STAFF ANALYSIS

HEBRON DEVELOPMENT PLAN

April 2012

Figure 6-12: C-NLOPB daily production and injection forecasts for Pools 1, 4 and 5.

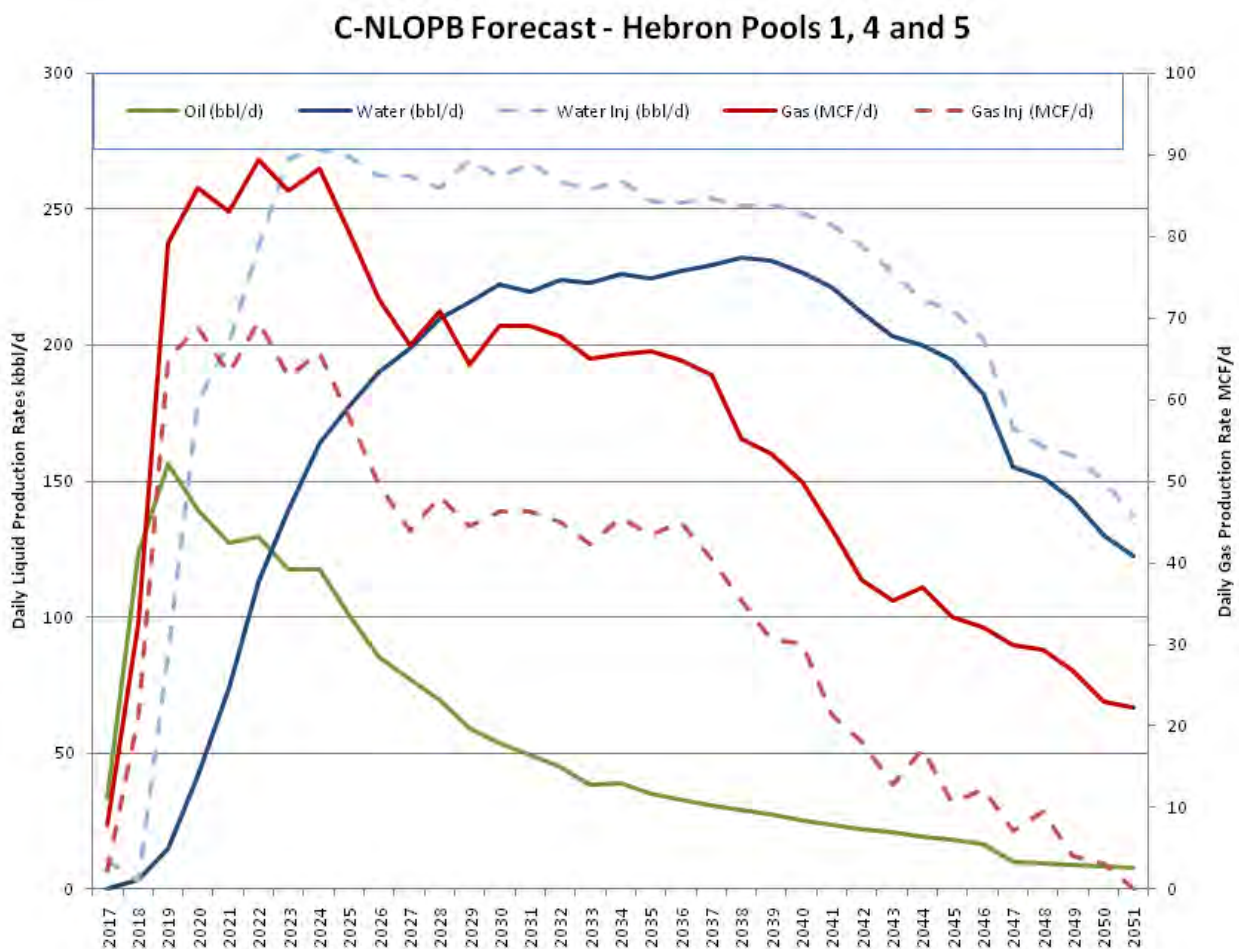
Board staff has developed an independent production forecast based on the results of simulation models for each of the pools. This forecast uses the base-case depletion plans, a field life from 2017 to 2051 and an assumed facility uptime of 93%. The assumed facility uptime is based on Hibernia GBS platform which has been operating in the NL Offshore Area for 15 years. The forecast prepared by Board staff is presented in Figure 6-12.

Figure C-8: B sand isochore map. Source: ExxonMobil Development Plan.

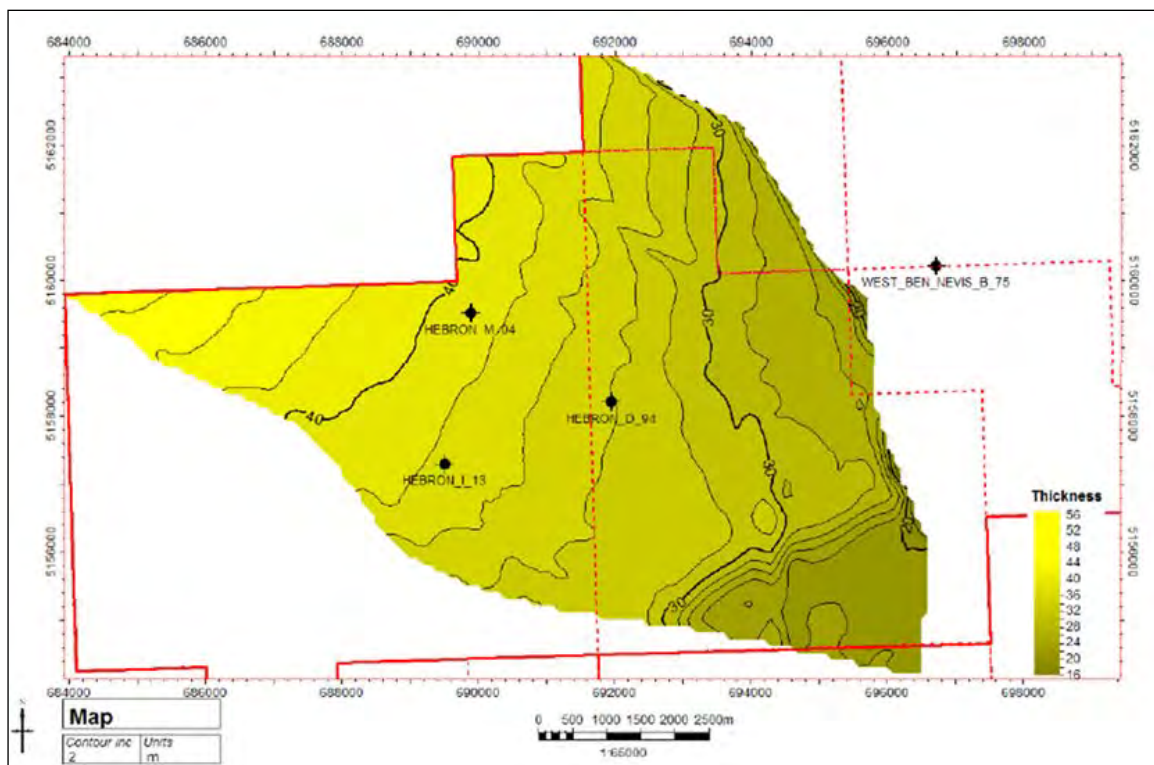
The Proponent's isochore map indicates approximately 40 m of B sand in both the Hebron M-04 and I-13 wells (Figure C-8) which is comparable to the Board staff's interpretation. The Proponent employed a method that uses variograms and "cloud transforms" to populate the rock volume with porosity and permeability properties and ultimately determine net pay.

Figure C-9: B sand net pay isopach map. Source: ExxonMobil Development Plan.

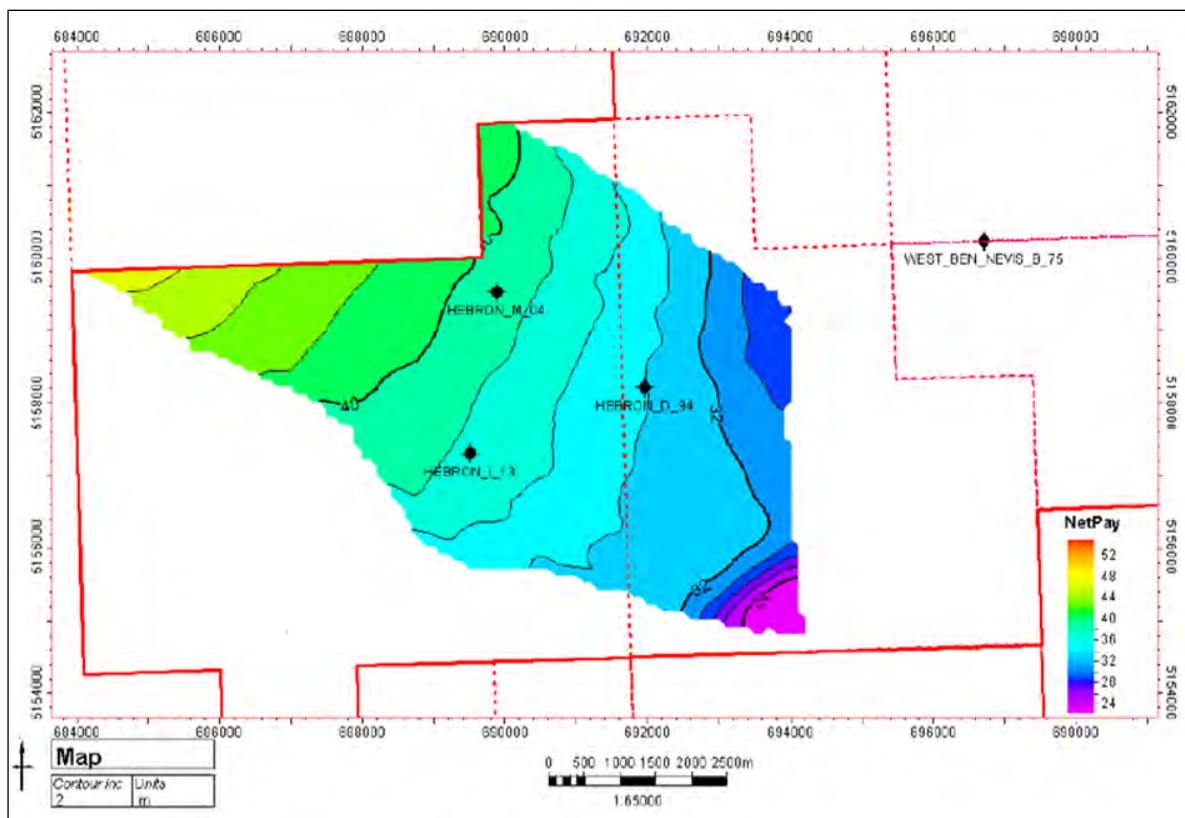
The Proponent's resultant net pay map (Figure C-9) appears to indicate a net pay in the vicinity of the Hebron M-04 and I-13 wells that is in the range of 38-40 m. The Proponent's STOOIP values for B sand oil appear to be based on approximately 10 m of net pay, which is the same value that was used for the B sand in the Hebron I-13 well.

Figure D-12: Hydrocarbon pore volume maps for Pool 2/3, showing alternate development well locations. t = end of field life.

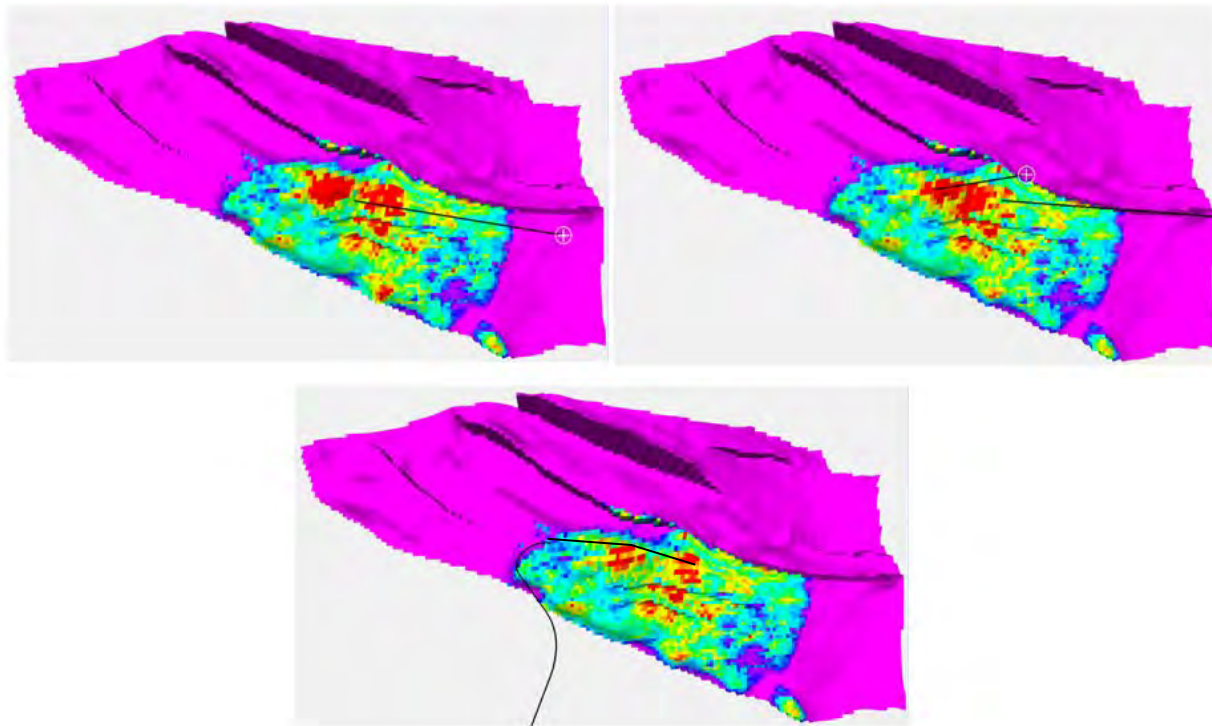
To determine the effectiveness of the proposed exploitation plan, HCPV maps were generated for Pool 3 using the base case model at 10 year intervals. Figure D-11 shows the HCPV map at times of 0, 10 years, 20 years and at the end of the field life. From these maps it can be demonstrated that the exploitation scheme proposed by the Proponent potentially leads to bypassed oil, particularly at the northern edge of

Figure D-16: Pool 5 base case, case with added injector and case with 3 producers and 1 injector.

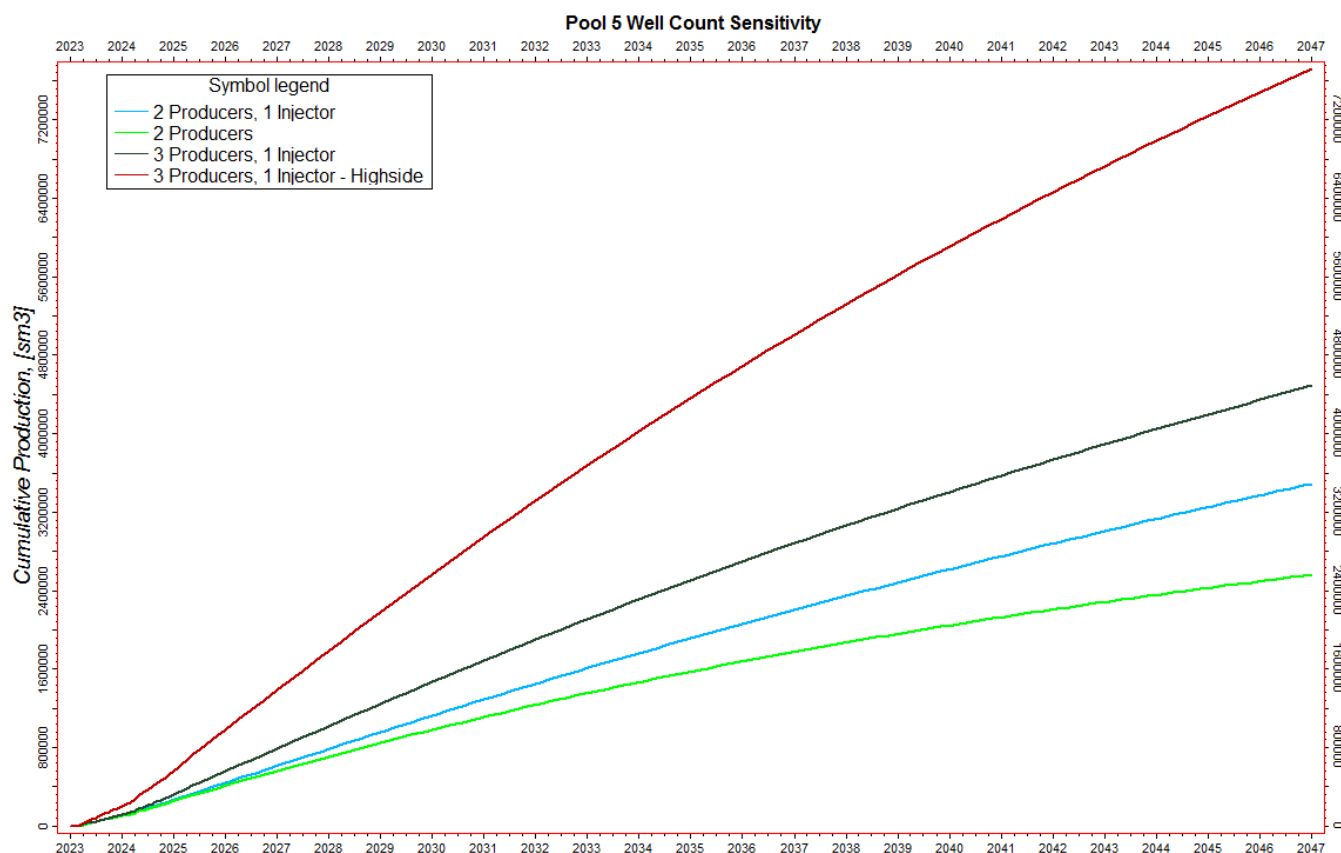
was run that included an additional producer in the northern portion of the field. With this additional producer, cumulative recovery increased to 4.5 MMm3. The Proponent also modeled a development scenario that included an added water injector in Pool 5 and a scenario with three producers and one injector. Its modeling produced similar results, suggesting incremental production with an ultimate recovery of approximately 3.2 MMm3 with an added injector, and 4 MMm3 with three producers and one injector. The upside potential for the case with 3 producers and one injector is 7.7 MMm3. Figure D-16 compares the base-case exploitation scheme to others that include a water injection well and an additional producer.
